HISTORIC LANDMARK COMMISSION STAFF REPORT

**Meck Residence
Major Alterations
505 E Third Avenue
PLNHLC2012-00384
September 6, 2012**

Applicant: Kimble Shaw,
architect representing
Lena & Ron Meck,
owners

SITE PLAN
 SCALE: 1/16" = 1'-0"

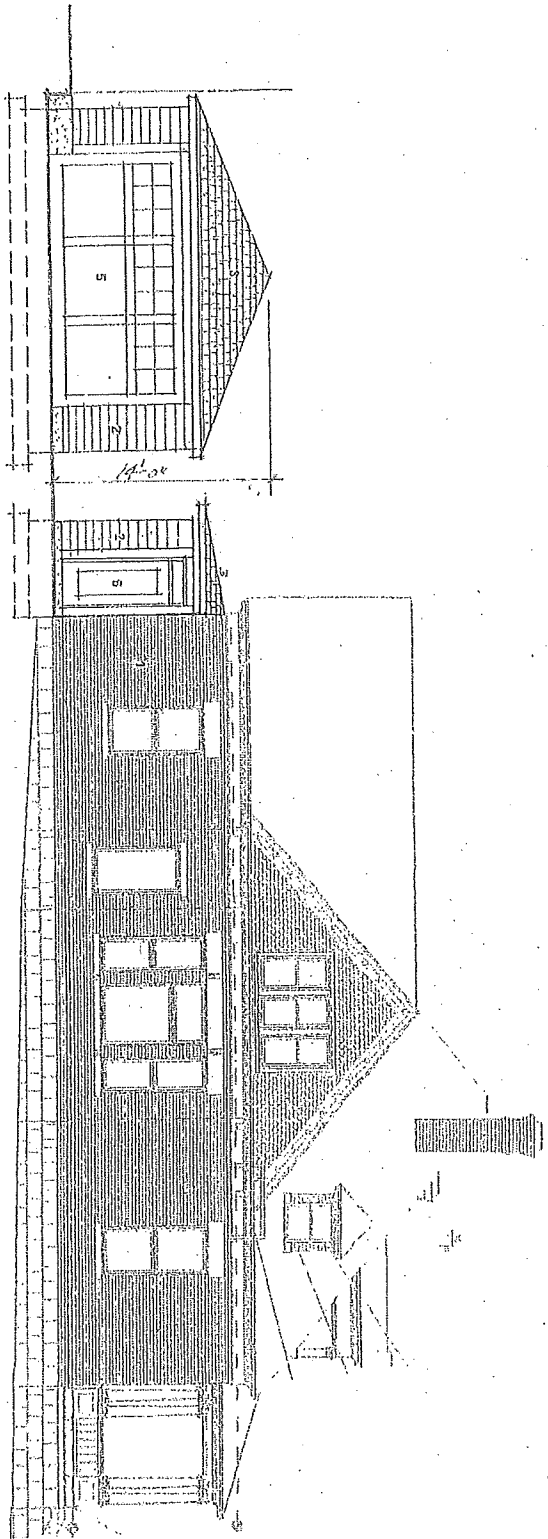
SCOPE OF WORK
 EXISTING GARAGE IS TOO SMALL TO FUNCTION AS A GARAGE & HAS LITTLE-TO-NO STRUCTURAL INTEGRITY; DRIVEWAY TO EXISTING GARAGE IS BROKEN & UN-EVEN & SHOULD BE REPLACED; ENCLOSED PORCH @ REAR OF HOUSE & STAIRS DOWN ARE POORLY BUILT & SIMPLY DON'T WORK WELL W/THE PLAN

THEREFORE, THE PROPOSAL IS TO REMOVE THE EXISTING GARAGE & ENCLOSED PORCH @ THE REAR OF HOUSE & BUILD A NEW 2-CAR GARAGE & 1-STOREY REAR ADDITION TO THE EXISTING HOUSE, ALONG W/ NEW DRIVEWAY & WALKWAYS.

WEST ELEVATION STUDY
SCALE: 1/8" = 1'-0"

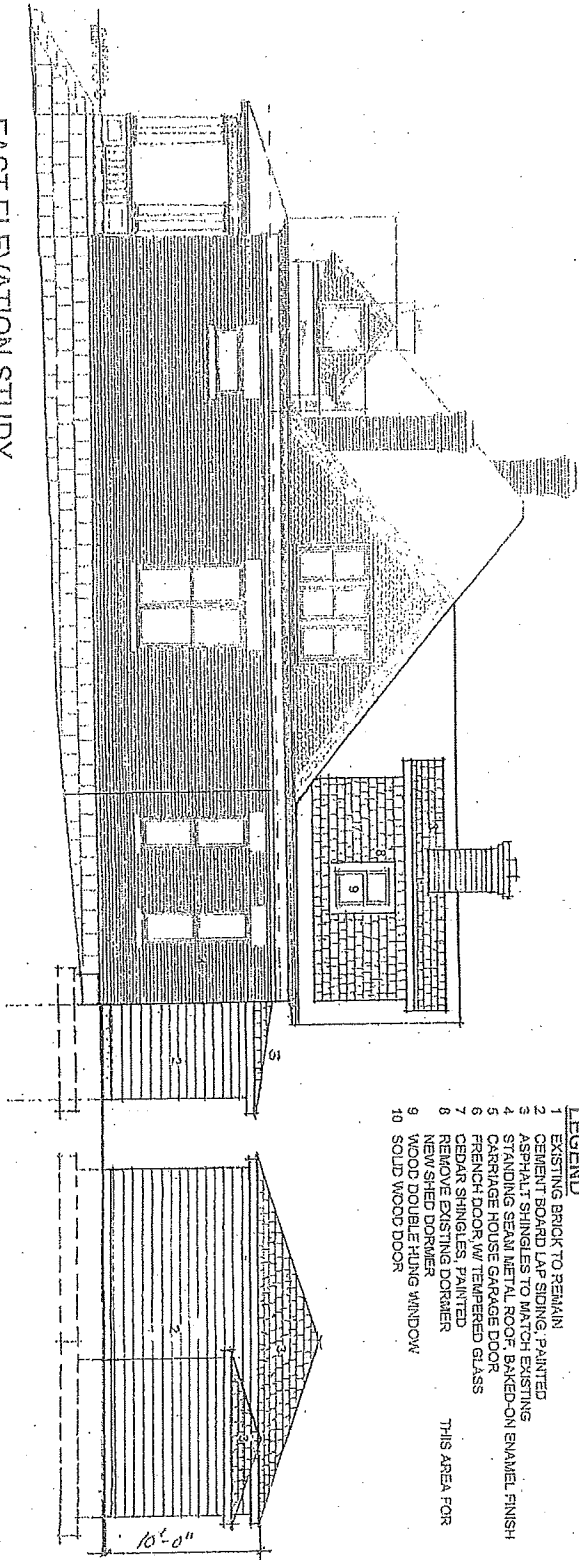
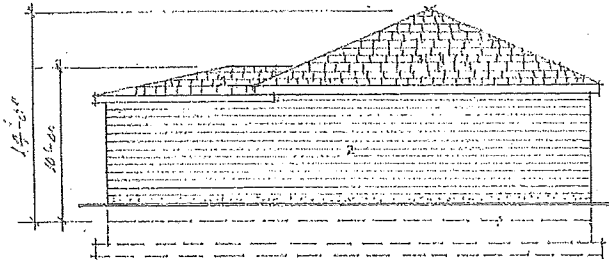
Analysis for Standard 2: Many of the materials that were used historically on accessory structures are those utilized in the construction of primary buildings. Alternative materials such as fiber cement products have been approved for new construction by the Commission in the past, when the siding has a smooth finish to match the appearance of historic wood siding and its design is similar to that seen traditionally.

Finding for Standard 2: The relationship of materials is visually compatible with the materials found in the neighborhood for similar buildings. The project meets the intent of this standard.
